**CITY OF PORTLAND, MAINE  
DEVELOPMENT REVIEW APPLICATION  
PLANNING DEPARTMENT PROCESSING FORM**  
-Planning Copy

Relocation of House  
Project Name/Description

RE: Application for Single Family House Relocation, Brewer Street, ID # 2005-0120

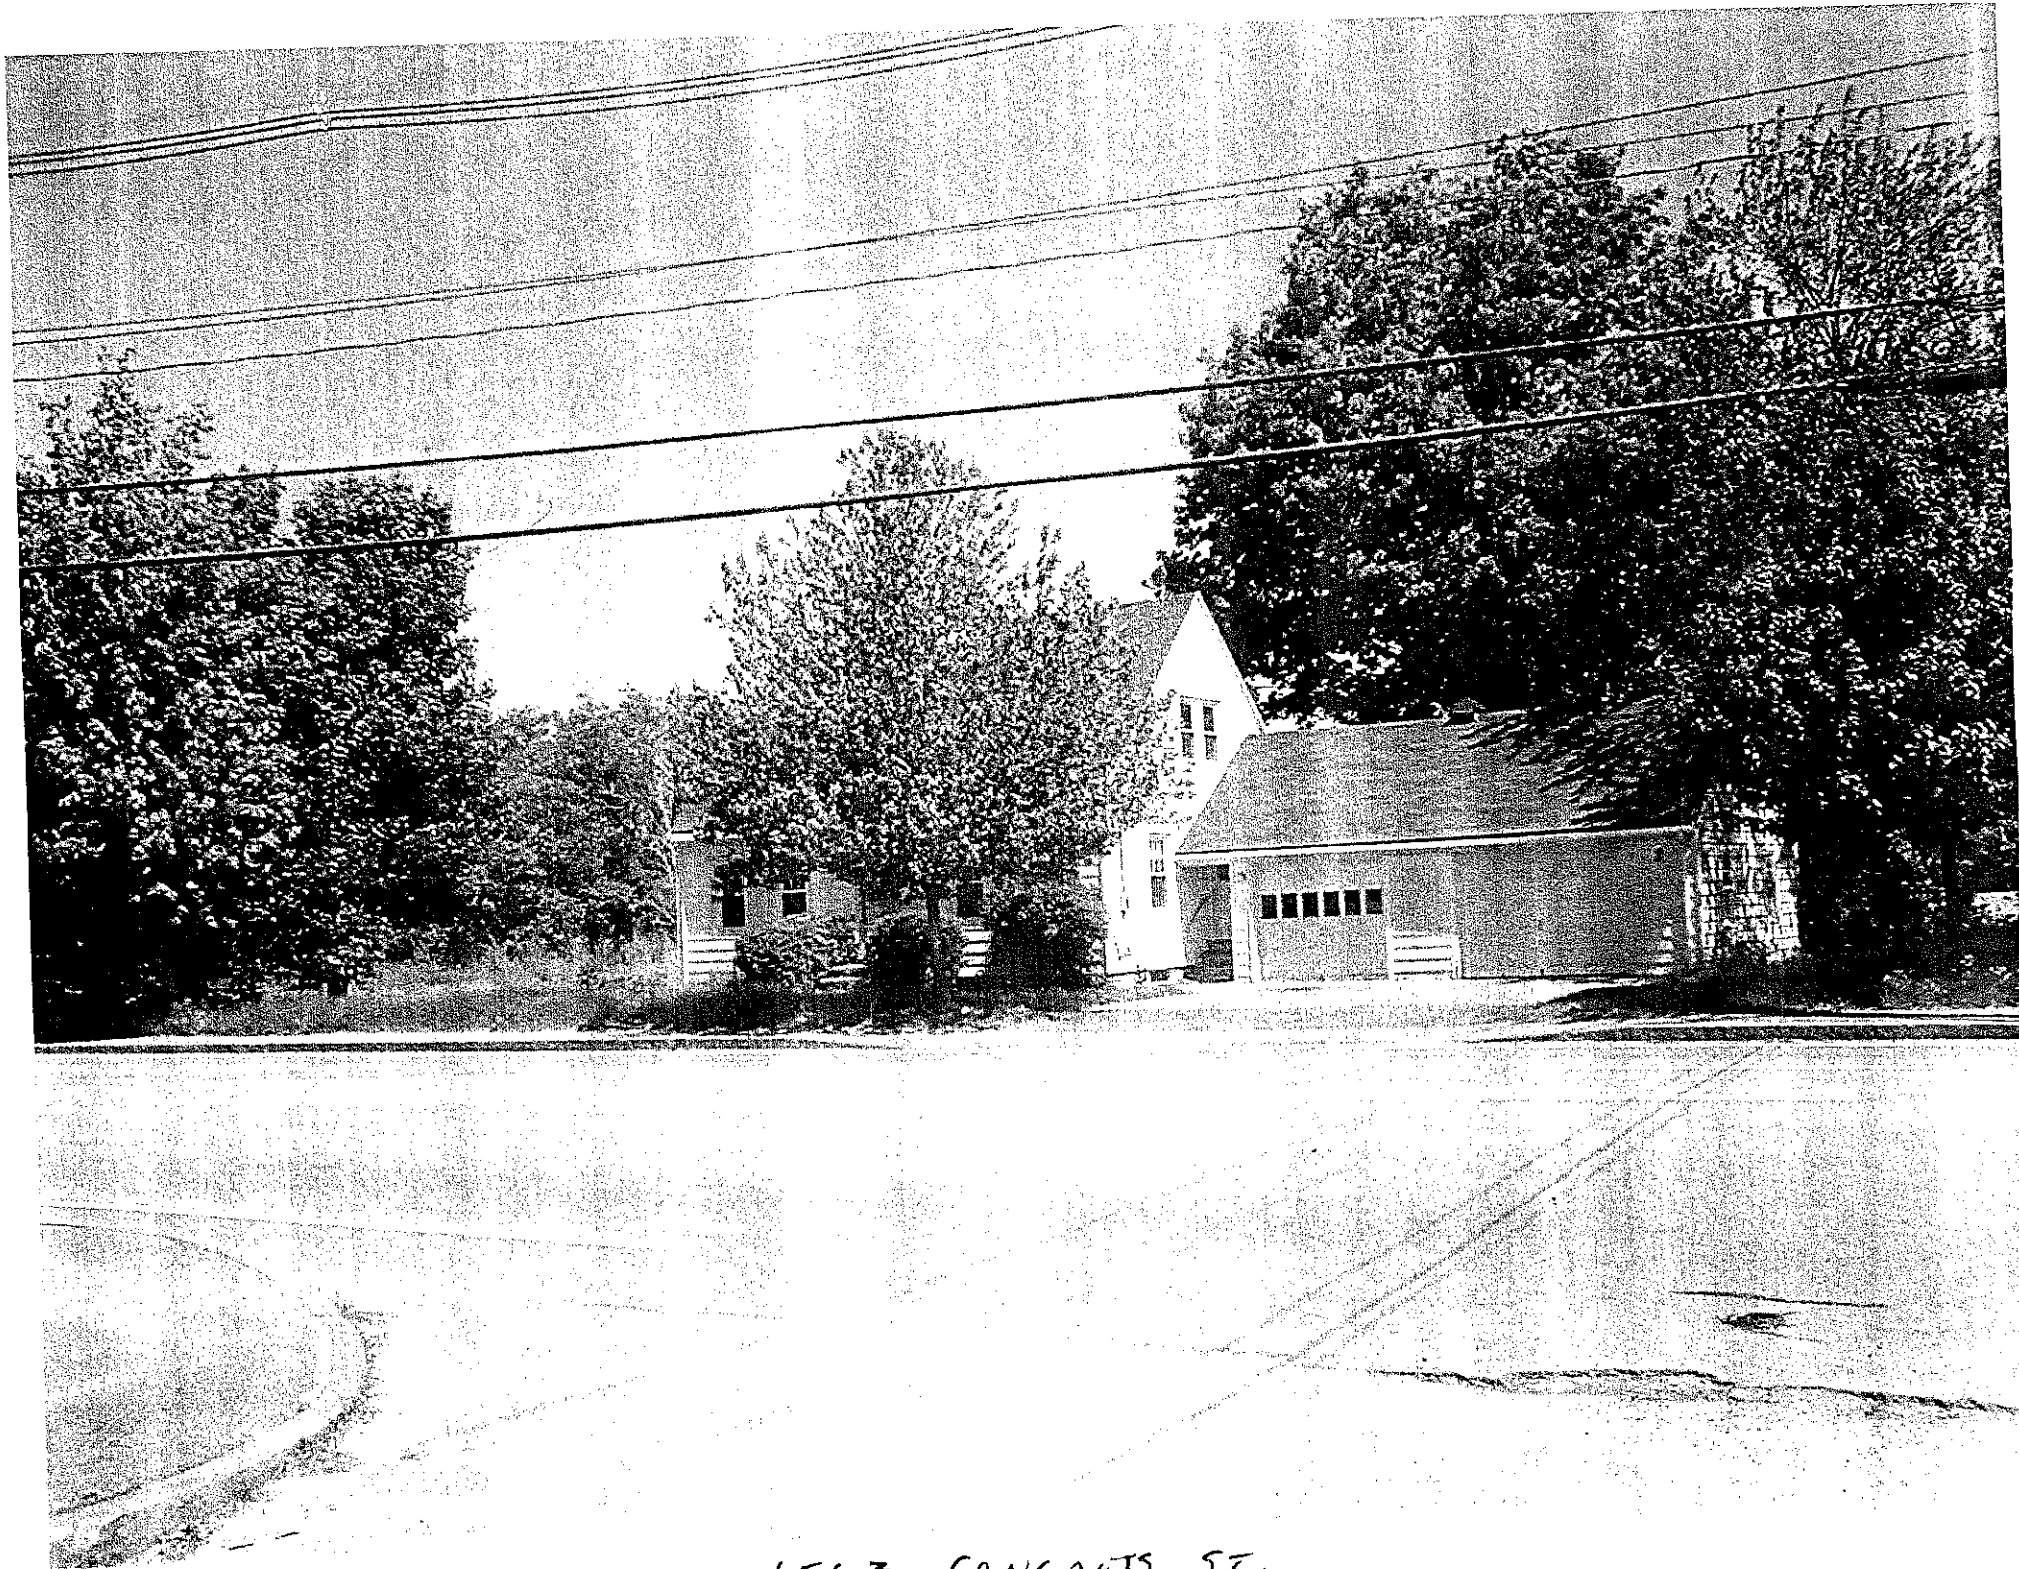
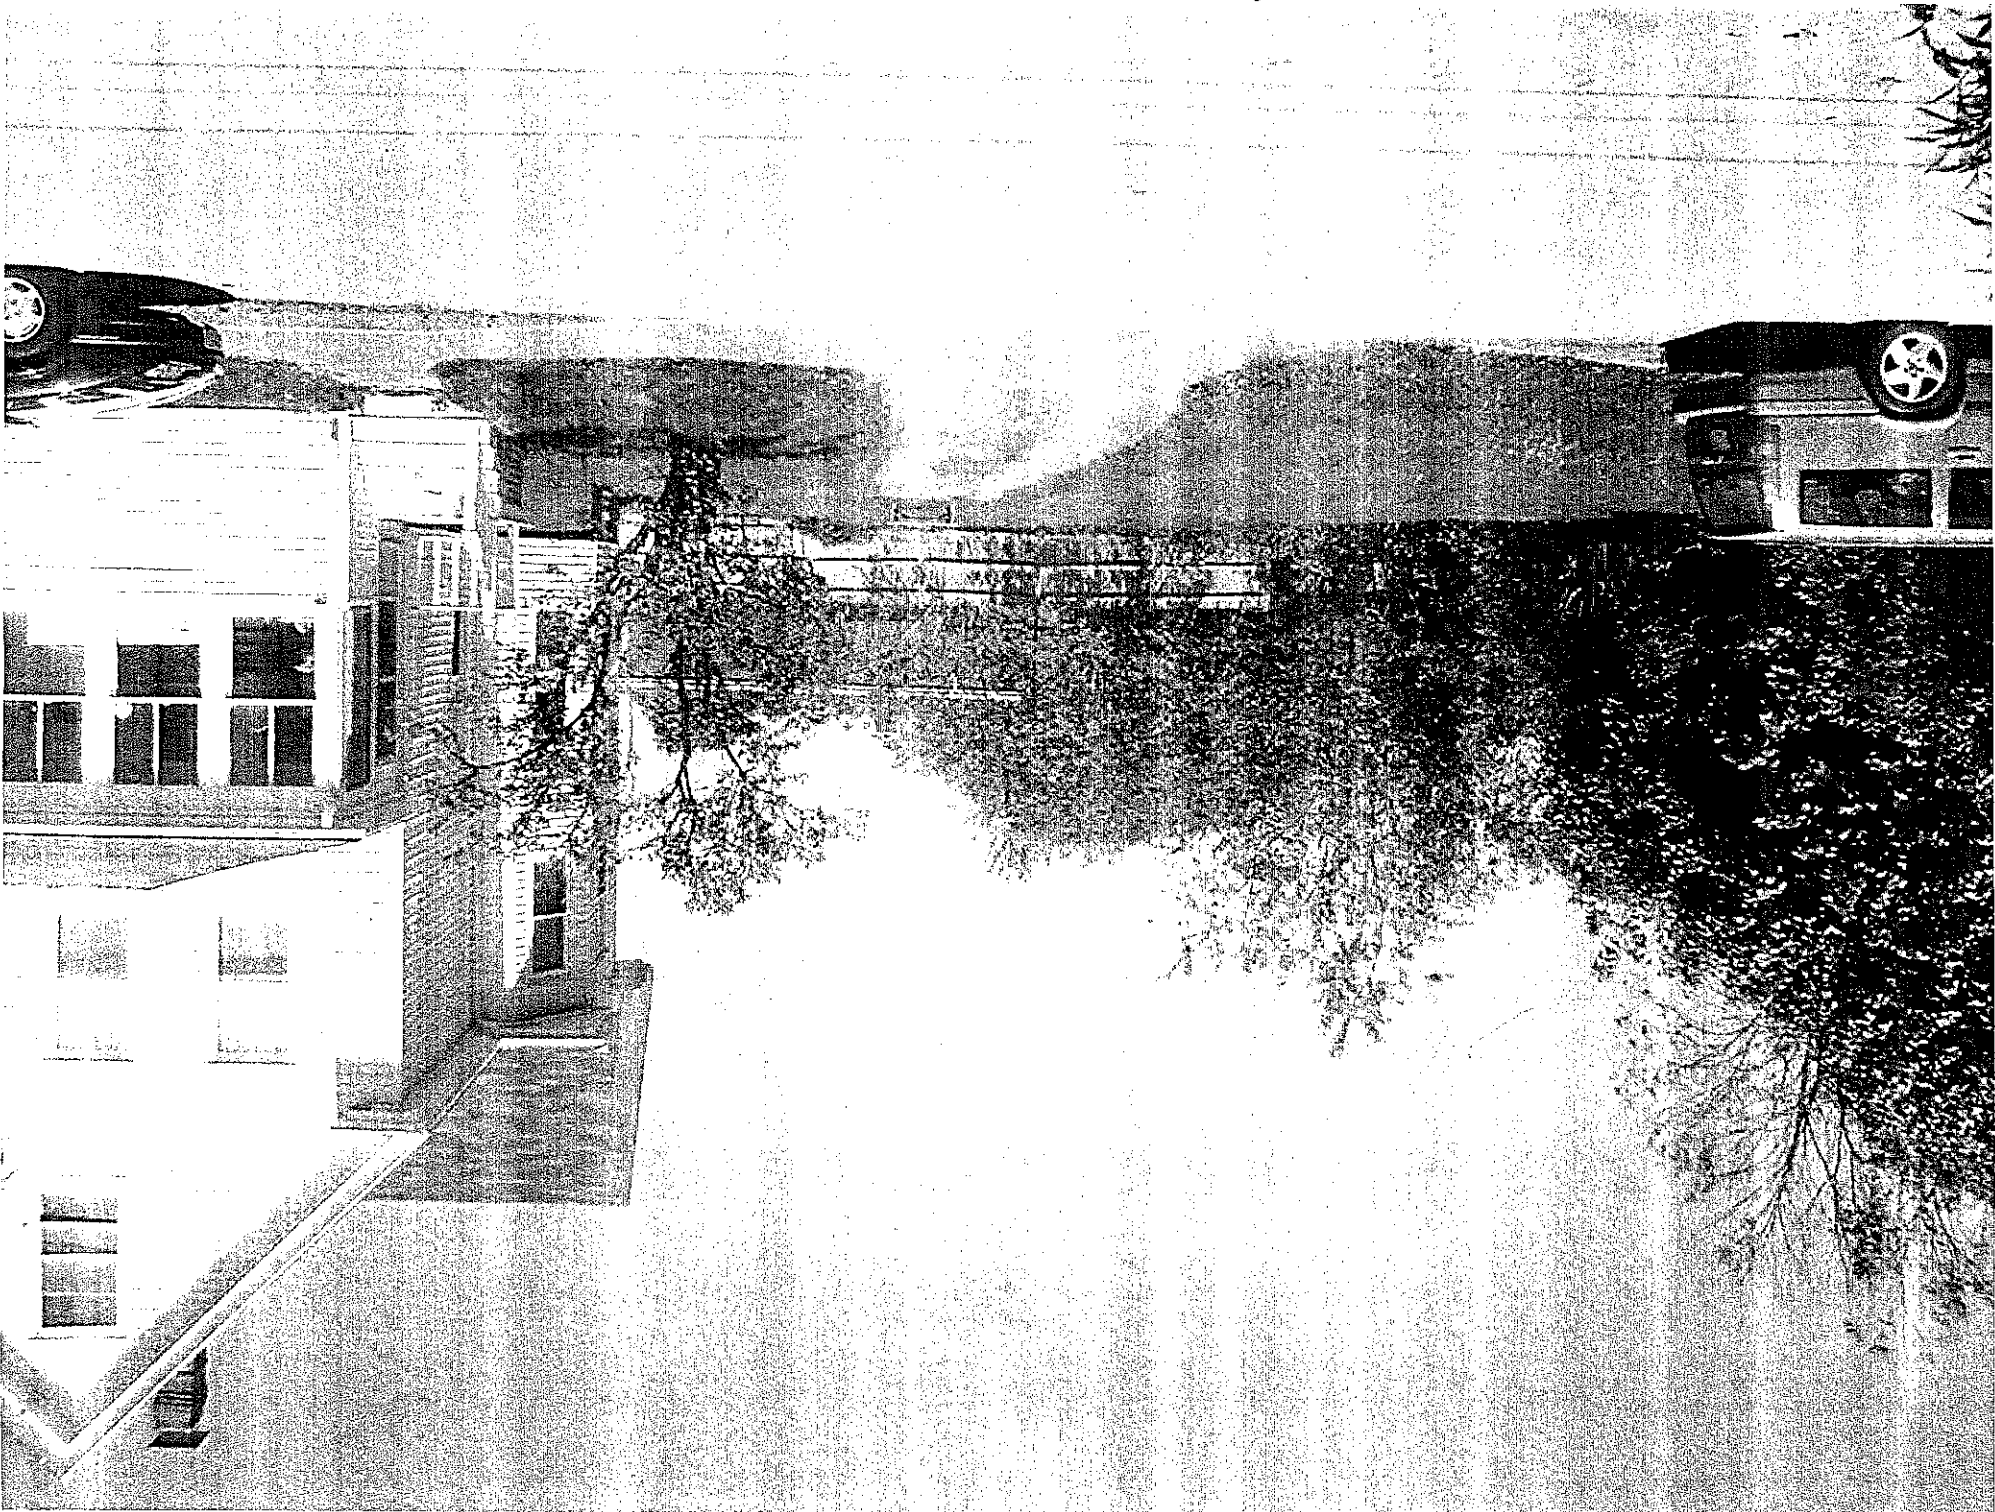
Thank you for your application to relocate a single family home from #1563 Congress Street to your lot on Brewer Street. Upon review of the site plan, the City's Planning Division has the following comments:

1. 4 parking spaces, 9'x19' each, are required (2 per unit). Please add 4<sup>th</sup> space to the site plan. Note: parking in the R-5 zone must be outside of the front setback.
2. Relating to item #1, it may be possible to add the 4<sup>th</sup> space in front of the garage and eliminate the proposed curb cut and paved driveway in front of the new building. Please consider.
3. Please show proposed topography/grading on your site plan.
4. Add erosion control (silt fence) as applicable.
